Subject: Class 3 Permit Modification Request for the Waste Isolation Pilot Plant
Hazardous Waste Facility Permit, Number NM4890139088-TSDF

Class 3 Permit Modification Request

Addition of a Concrete Overpack Container Storage Unit

**Waste Isolation Pilot Plant
Carlsbad, New Mexico**

Figure A1-38
Concrete Overpack Container Storage Unit

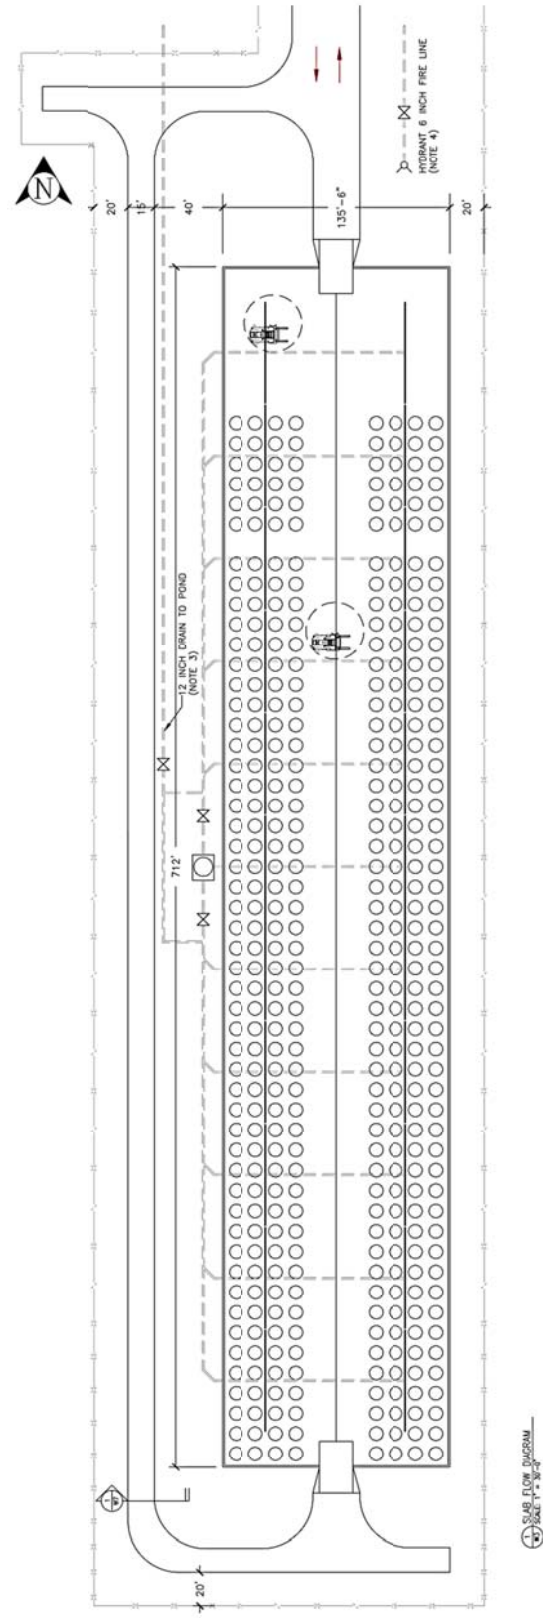
- Revise Attachment A1, Container Storage, Table A1-2, Waste Handling Equipment Capacities
- Revise Attachment A1, Container Storage, Figures to add two figure drawings: A1-38 for the concrete overpack unit area and A1-39 for the concrete overpack container)

The area south of the rail siding (see Figure A1-38) will be used for storage of TRU mixed waste containers within concrete overpacks. The Overpack Unit provides storage space for up to 65,280 ft³ (1,836 m³) of TRU mixed waste, contained in up to 408 loaded engineered concrete overpacks. Secondary containment and protection of the waste containers from standing liquid are provided by the concrete overpacks. Concrete overpacks placed in the Overpack Unit will remain closed while in this area. The maximum residence time for waste stored in concrete overpacks is 365 days from the date TRU mixed waste containers were placed into the concrete overpack.

Figure A2-12
WIPP Facility Surface and Underground CH Transuranic Mixed Waste Process Flow Diagram

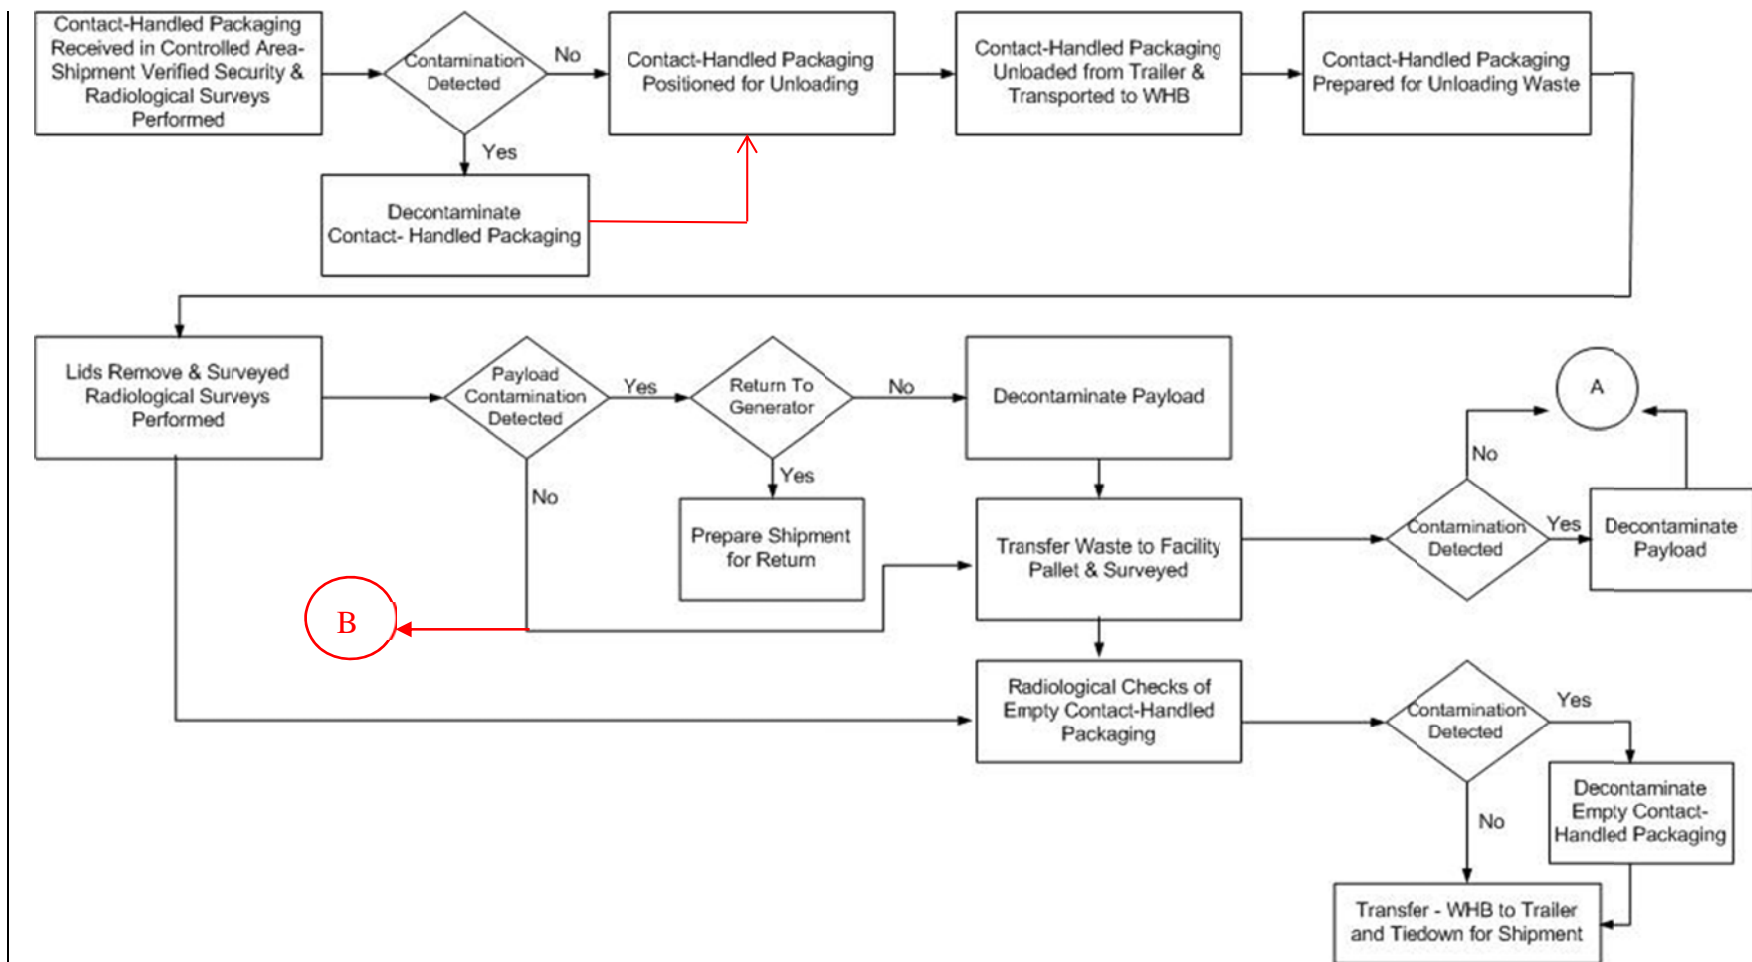
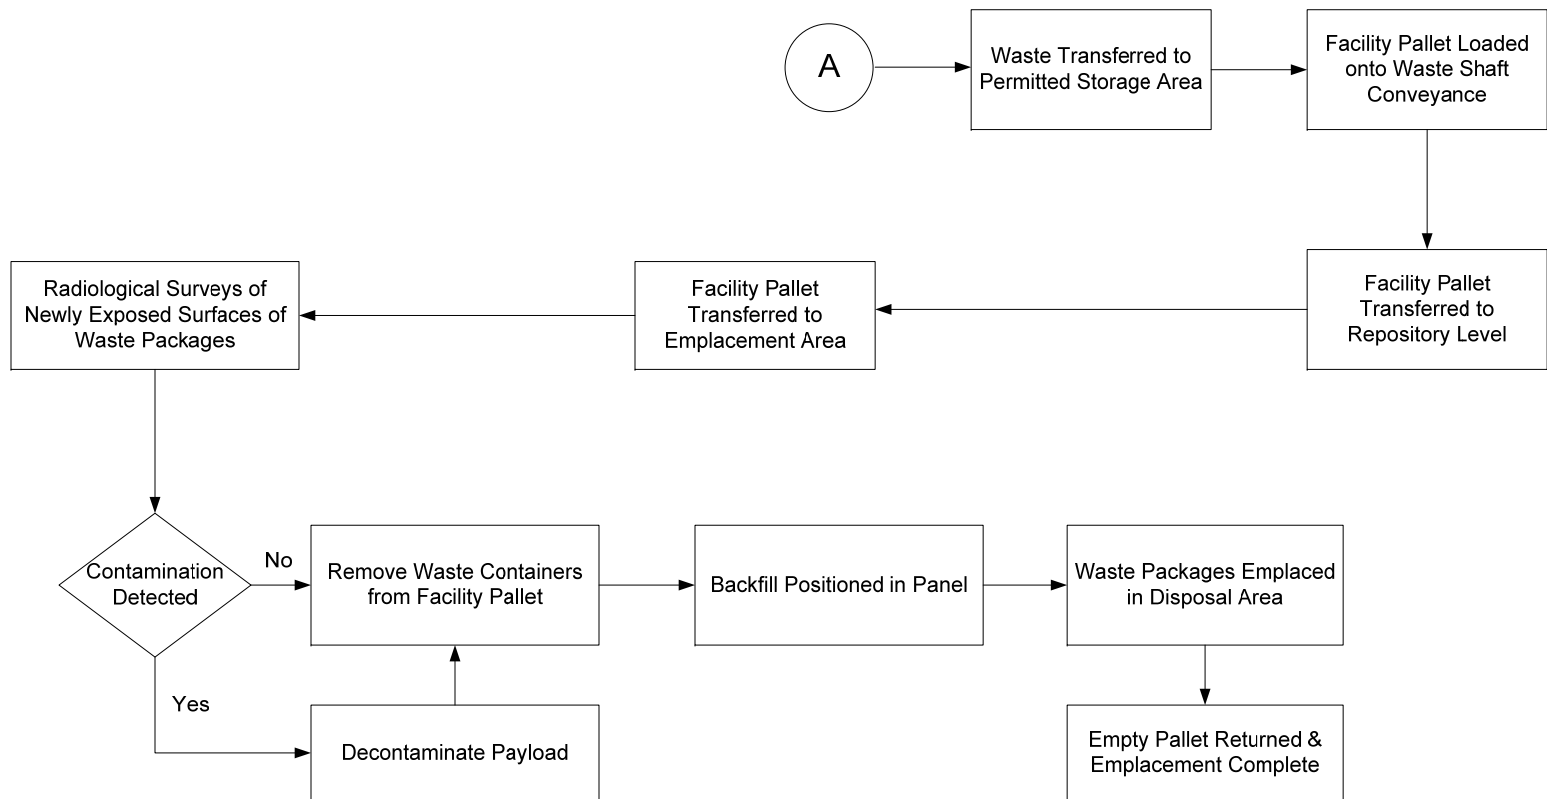
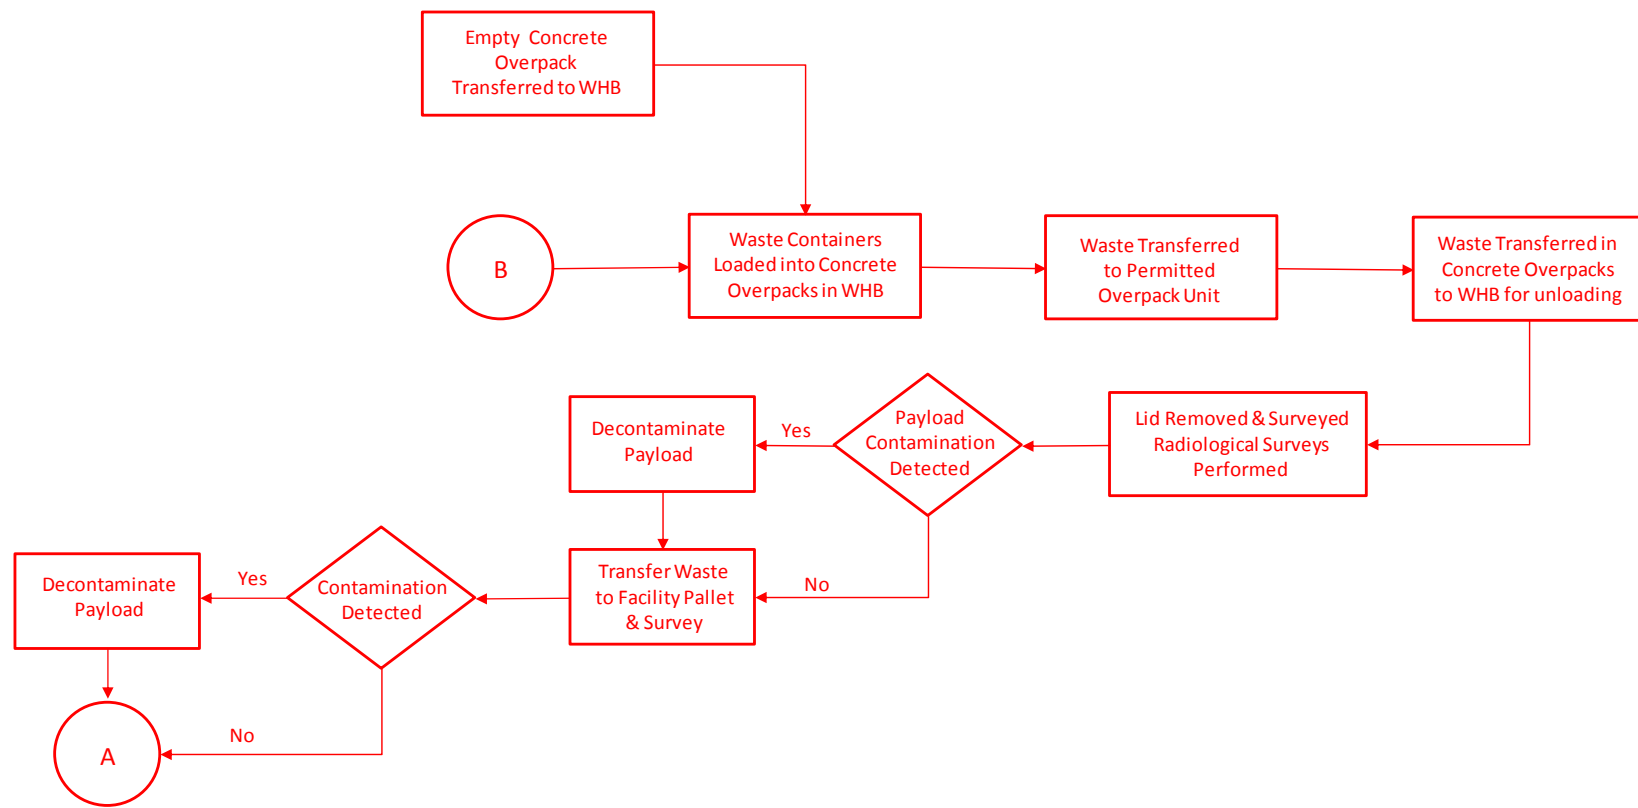
- Revise Attachment A2, Geologic Repository, Figure A2-12, WIPP Facility Surface and Underground CH Transuranic Mixed Waste Process Flow Diagram
- Revise Attachment A4, Traffic Patterns, to add new Section A4-5, Concrete Overpack Container Storage Unit Traffic

Attachment A2, Table A2-1	<p>Added row with “Concrete overpack forklift” in first column and “46,100 lbs.” in second column.</p> <p>Added row with “Concrete overpack with lid” in first column and “46,100 lbs.” in second column.</p> <p>Added row with “Concrete overpack with lid” in first column and “32,100 lbs.” in second column.</p>	B-22
Attachment A2, Figure A2-12	Updated both pages of this figure to show the updated process for mixed waste.	B-23

Figure A4-8
Waste Transport Routes in WHB – Concrete Overpack Loading and Unloading

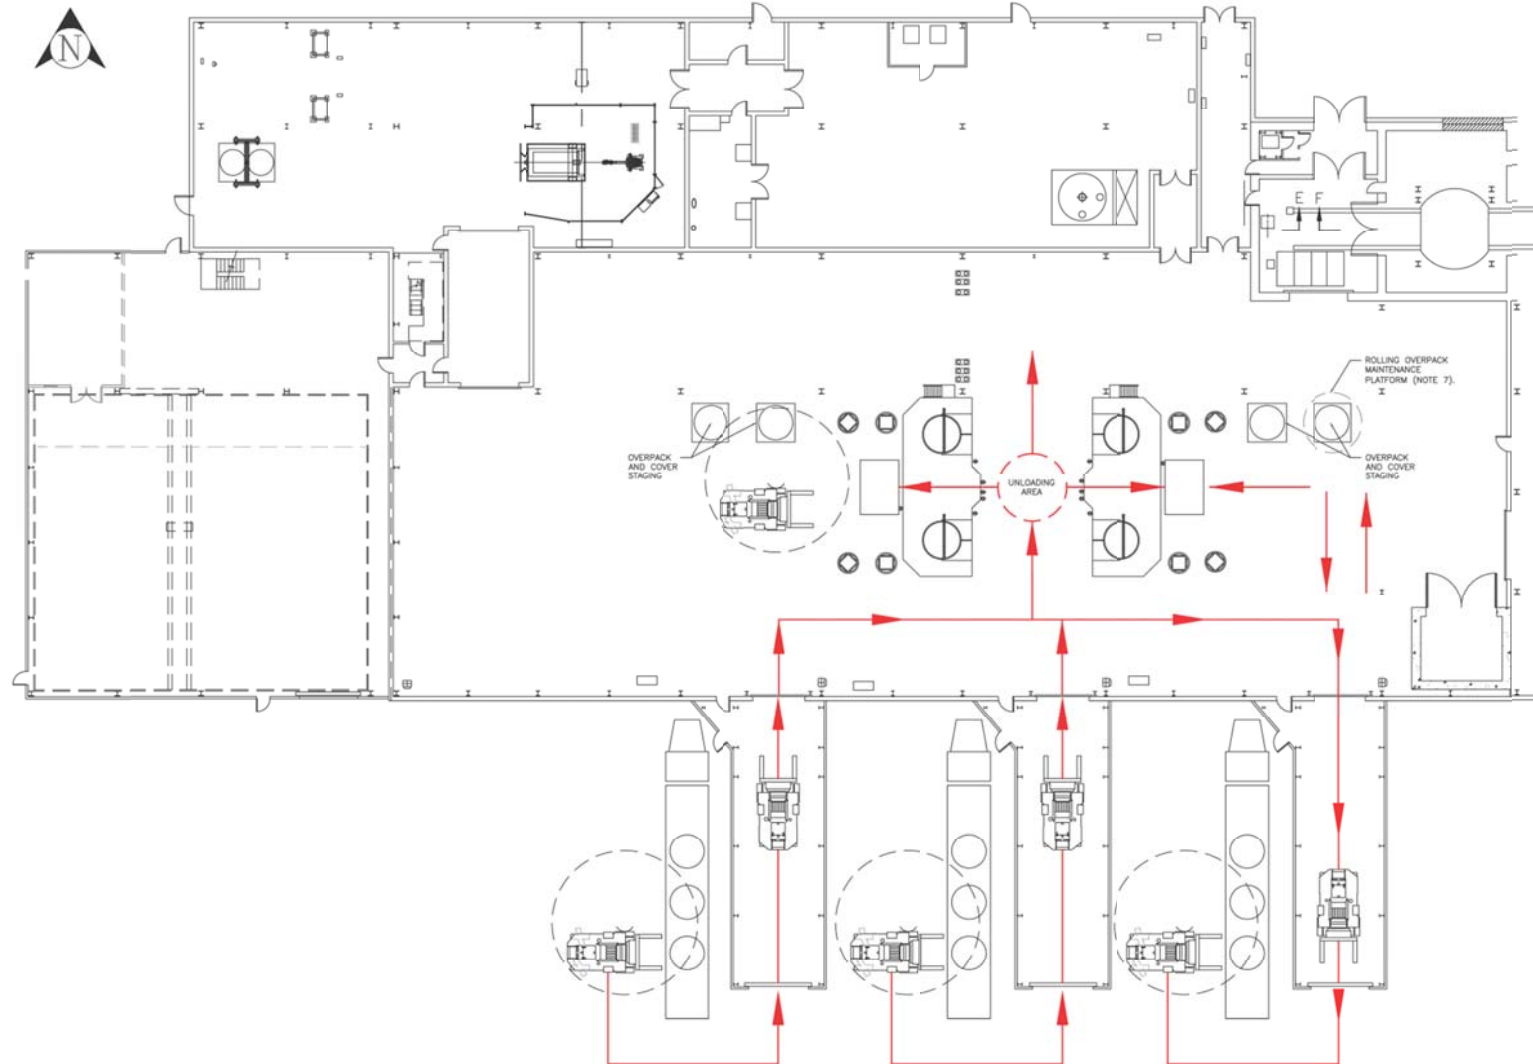
- Revise Attachment A4, Traffic Patterns, Figures add two new figures, Figure A4-8 and Figure A4-9 to show traffic patterns for the new concrete overpack container storage unit)

Figure B2-2
Planimetric Map - WIPP Facility Boundaries

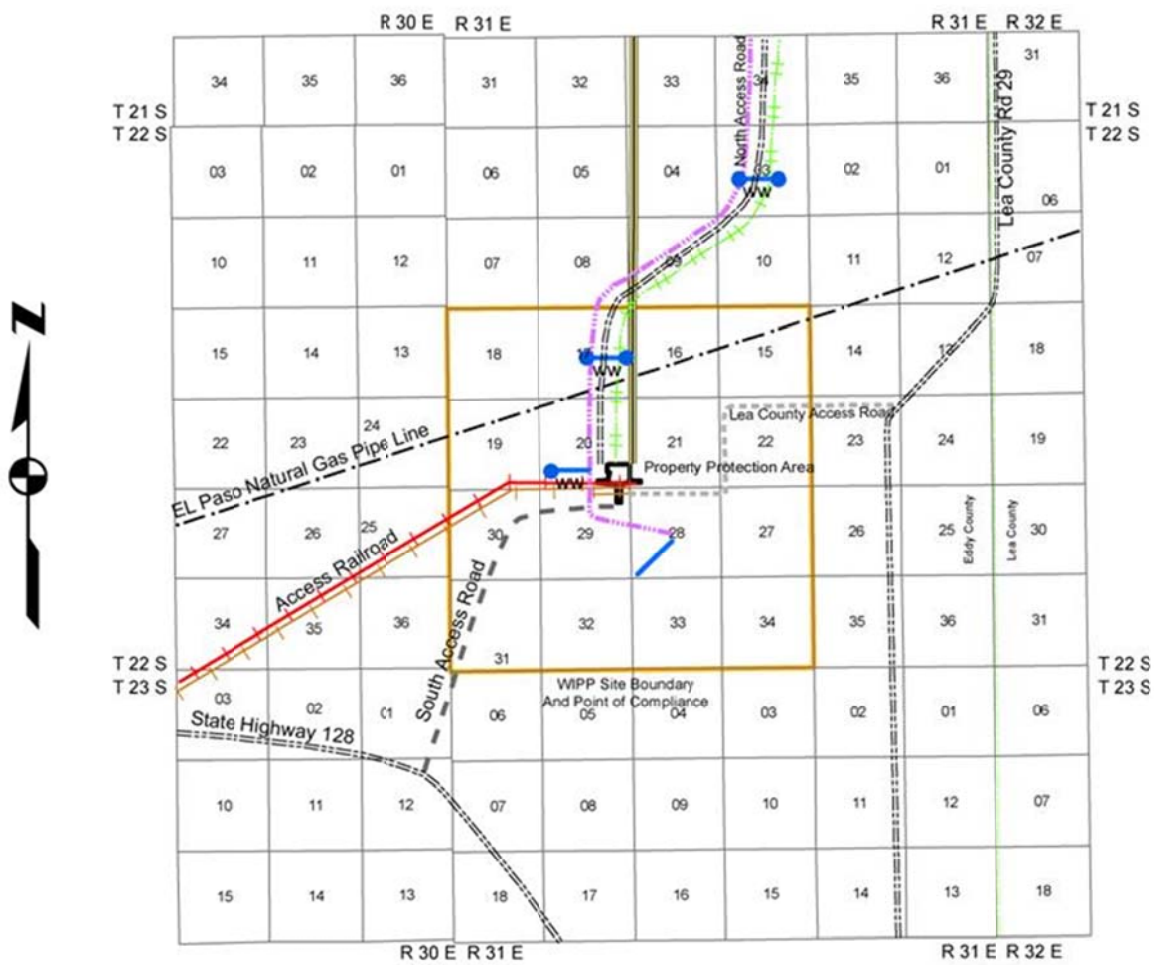
- Revise Attachment B, Hazardous Waste Permit Application Part A
- Revise Attachment B, Hazardous Waste Permit Application Part A, Appendix B2 Maps to replace Figure B2-2 with a more legible figure and Figure B2-2a Note 1 is being

revised to change the Property Protection Area (**PPA**) from approximately 35 acres to approximately 40 acres.

1. The Property Protection Area is a fenced area of approximately 40 acres. It contains all surface facilities with the exception of salt storage piles, parking lot, landfill and waste water stabilization lagoons.
2. Zone II overlies the maximum extent of the Area available for underground development.
3. WIPP Site Boundary (WSB) provides a one mile buffer area around the area available for underground development.

Figure B3-5
Concrete Overpack Container Storage Unit

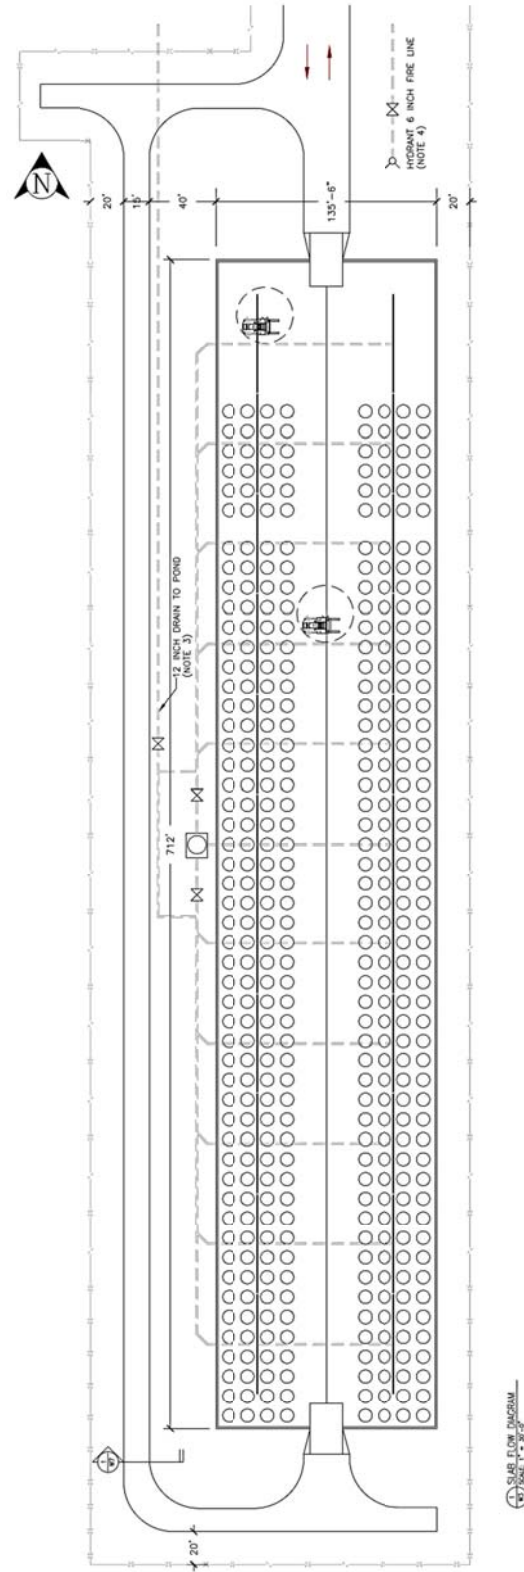
- Revise Attachment B, Hazardous Waste Permit Application Part A, Appendix B3 Facilities to add Figure B3-5 to show the Concrete Overpack Container Storage Unit
